SUBJECT: REVISION "A" TO TECHNICAL BULLETIN 212-03-189:

**REPLACEMENT OF LANDING LIGHT MECHANICAL RELAY
ASSEMBLY WITH A SOLID-STATE SWITCH MOUNTED ON A
PRINTED WIRING BOARD.**

NO. G5400-97-001

SUBJECT: Replacement of mechanical relay assembly with a solid state switch mounted on a printed wiring board.

Landing Light (old configuration)
Figure 1

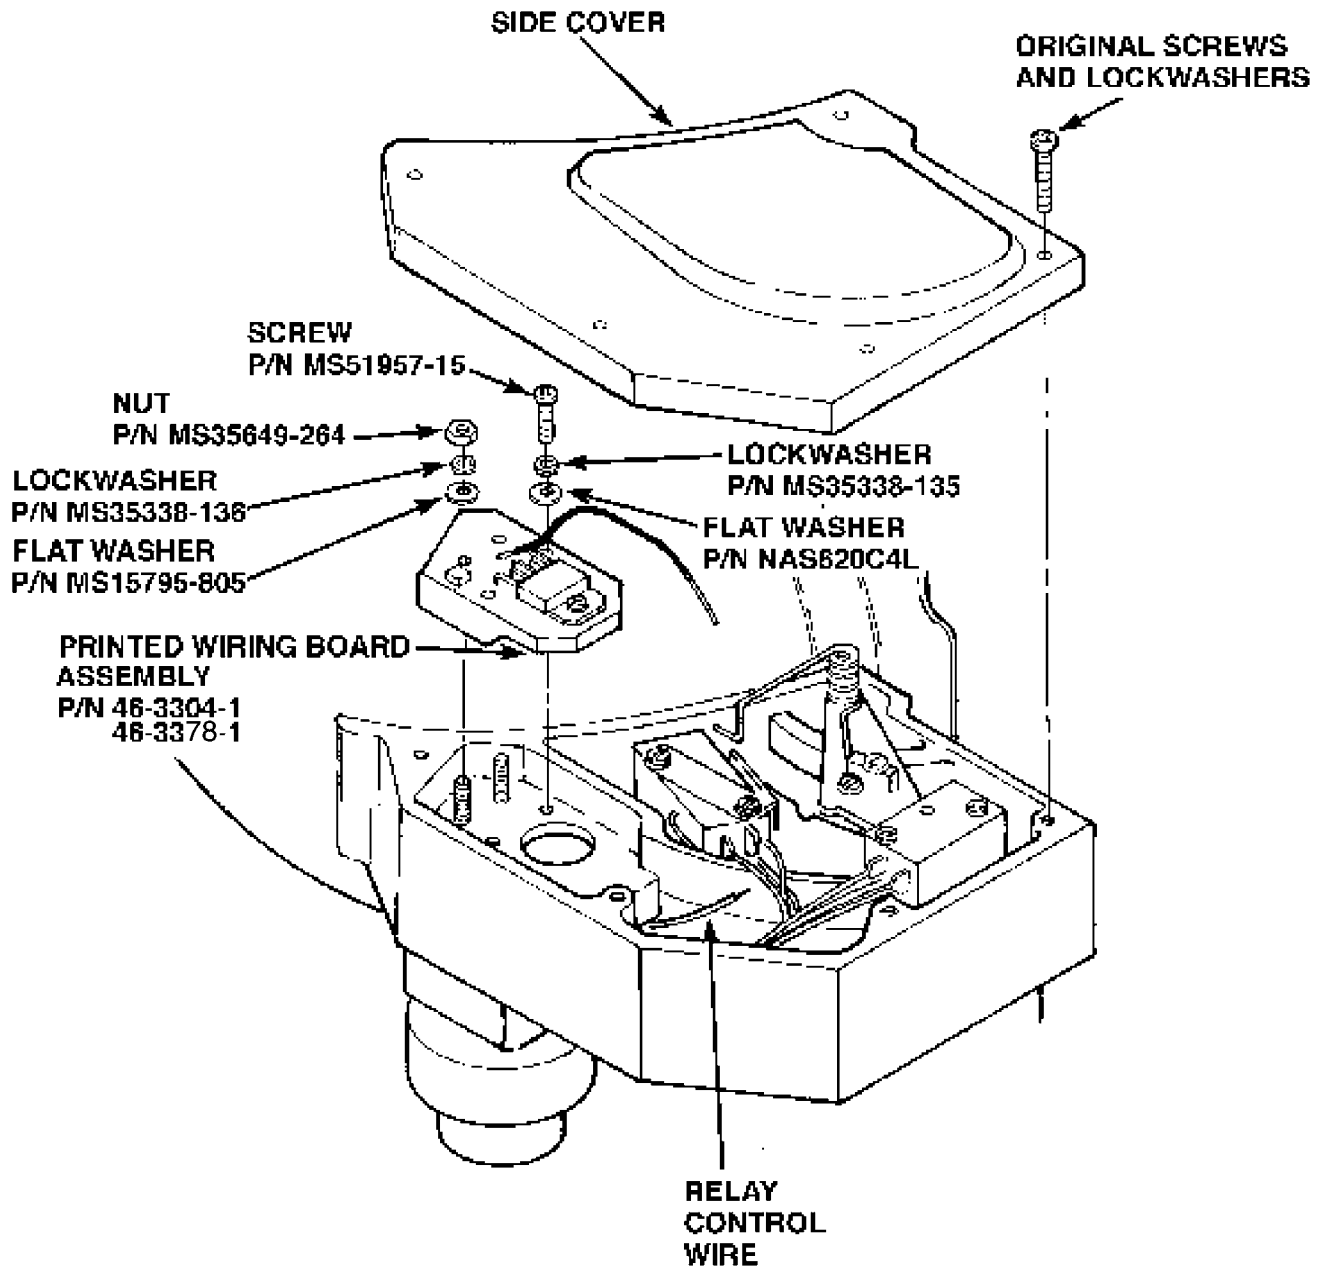
Bell Helicopter has become aware of the mechanical relay contact's "welding" themselves closed in the landing light assembly. This situation will cause the landing light to stay in the "on" position even when landing light switch was turned "off". The intent of this bulletin is to provide instructions to replace the mechanical relay with a new solid-state switch mounted on a printed wiring board.

DESCRIPTION: The intent of this bulletin is to provide instructions to replace the mechanical relay with a new solid state switch mounted on a printed wiring board.

1. **See Figure 1,** Remove five screws (60), lock washers (65) and side cover (55) from the drive housing assembly (350). Keep the side cover and attaching parts.
2. Remove the mechanical relay assembly (240) as follows:
 - (a) Remove two screws (245) and lock washers (250) to loosen relay (240). Discard screws (245) and lock washers (250).
 - (b) Cut relay control wire close to relay (240) and discard relay.
3. Remove two nuts (225), lock washers (230) and contact block assembly (220) from the drive housing assembly (350). Discard the contact block assembly (220) and the attaching parts.
4. Leave the two threaded studs (295) in place.
5. Strip approximately 0.25 inch (6,35 mm) from the end of the relay control wire.
6. Use a soldering iron to tin the end of the relay control wire.

7. Using the splice provided with the kit splice the end of the wire on the new printed wiring board assembly to the relay control wire as shown in Figure 2. Slide the heat shrink tubing also provided over the splice and shrink in place.
8. **See Figure 2**, Position the new printed wiring board assembly over the threaded studs (295), then secure the new circuit card assembly with two new washers, P/N MS15795-805, new lock washers, P/N MS35338-136, new nuts, P/N MS35649-264, new flat washers, P/N NAS620C4L, new lock washers, P/N MS35338-135 and new screws, P/N MS51957-15.

9. **See Figure 1**, Position the side cover (55) on the drive housing assembly (350) and secure with original five lock washers (65) and screws (60).
10. Test the landing light in accordance with referenced CMM or applicable aircraft operating procedures.
